CITY OF SEQUIM DEPARTMENT OF COMMUNITY DEVELOPMENT
STAFF REPORT AND DIRECTOR'S DECISION
"Jamestown S'Klallam Tribe Outpatient Clinic" Design Review Application
File No. CDR 20-001

Owner/Applicant: Jamestown S'Klallam Tribe contact: Brent Simcosky
808 N. 5th Avenue
Sequim, WA 98382

ILLUSTRATION 3

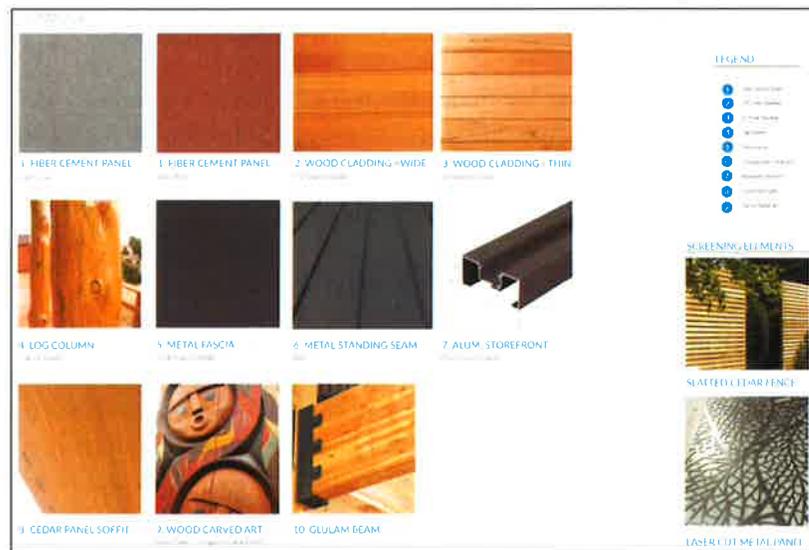
Staff comment: The project proponent has graphically submitted a proposed color palette along with the proposed materials for their project on page 4 of the plan set. The palette includes all the materials and colors proposed for the project. As shown on the plan set pages 5 and 6, there are no more than three distinct colors used on the proposed building (stained cedar, dark red, and dark gray). All colors will have low reflectivity and blend well with the surrounding environment (See Illustrations 1 and 2 above).

ILLUSTRATION 4-SITE PLAN WITH PARKING LOT LAYOUT

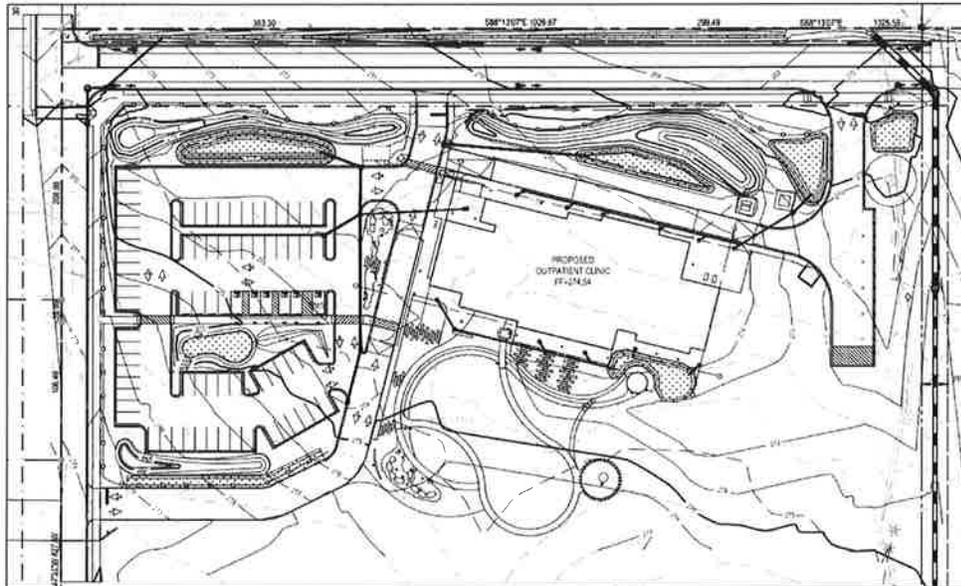
Staff comment: The design for the project’s off-street parking would minimize visual impact to streets and adjacent spaces/properties by providing landscaping and creative low impact stormwater management techniques. Parking areas are designed to have safe and efficient ingress and egress for vehicles and have been configured and designed to reduce the overall mass of paved surfaces. The off-street parking for 96 vehicles has been visually and functionally divided into smaller parking areas throughout the parking lot. Parking is setback no less than ten feet from abutting properties and rights-of-way with landscape buffers and no off-street parking is located forward of the front façade of the proposed building.
